IREDELL COUNTY HEALTH DEPARTMENT

(SEPTIC TANK) IMPROVEMENTS PERMIT AND CERTIFICATE OF COMPLETION
(Ground Absorption Sewage Disposal System – G. S. Chapter 130-Article 13C)

OWNER OR CONTRACTOR William C. Redmond DATE 9-3-76 PERMIT NO. _____

Plot of System

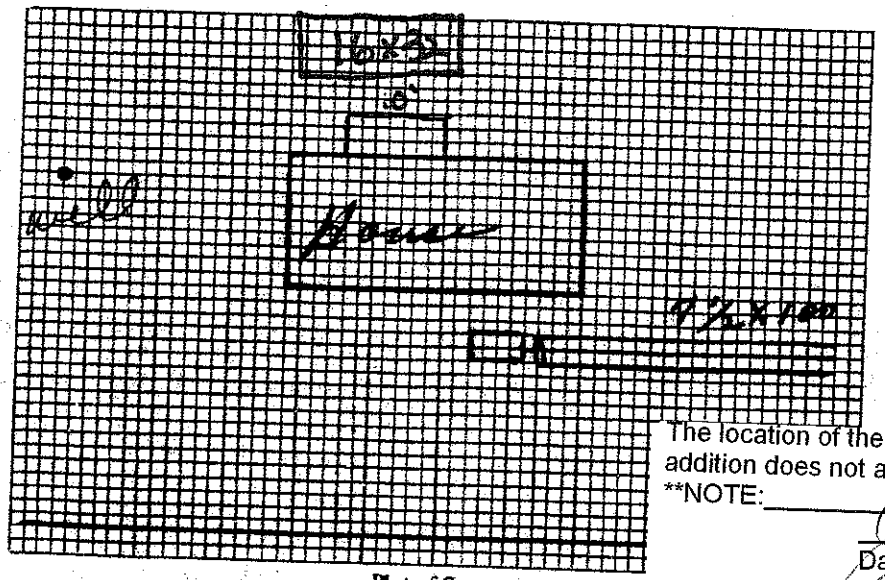
The location of the proposed Swimming Pool addition does not appear to impact the existing septic system.
**NOTE: _____

COMMENTS: Extra dirt to be filled in over tank
Downspouts should be diverted away from Tank & line
